To: INCITS Technical Committee T10  
From: Fred Knight, Network Appliance  
Email: knight@netapp.com  
Date: 5 December, 2008  
Subject: SBC-3 Thin Provisioning Commands

## Proposal:

Figure B – Logical Block State Transitions

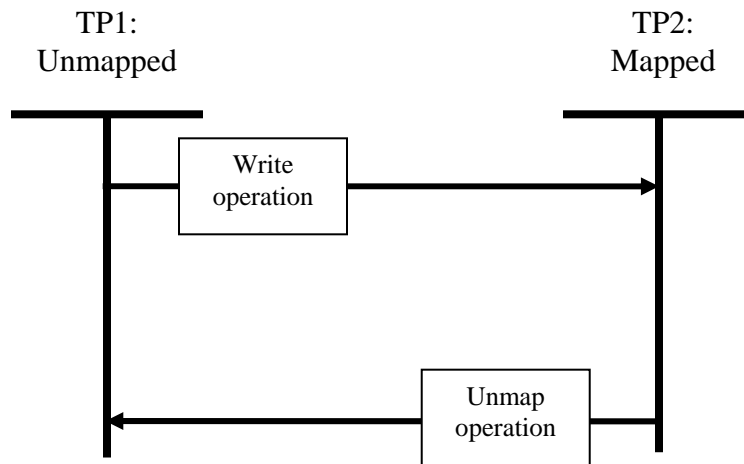
Transitions between the mapped and unmapped state are shown in figure B.

#### 4.4.1.2.1 Transition TP2:Mapped state to TP1:Unmapped state

This transition occurs when an unmap operation completes without error (see 4.4.1.5.2). As a result of this transition, the user data retrieved by the next read operation ~~or verify operation~~ may be indeterminate (see [TPRZ bit in READ CAPACITY\(16\) parameter data \(6.4.3\)](#) and [UNMAP command \(5.x\)](#)).

#### 4.4.1.3.1 Transition TP1:Unmapped state to TP2:Mapped state

- a) shall occur when a write operation occurs. As part of processing a write operation, the device server may cause LBAs other than those specified by that write operation to transition from unmapped state to mapped state; or
- b) may occur at any other time for vendor specific reasons.
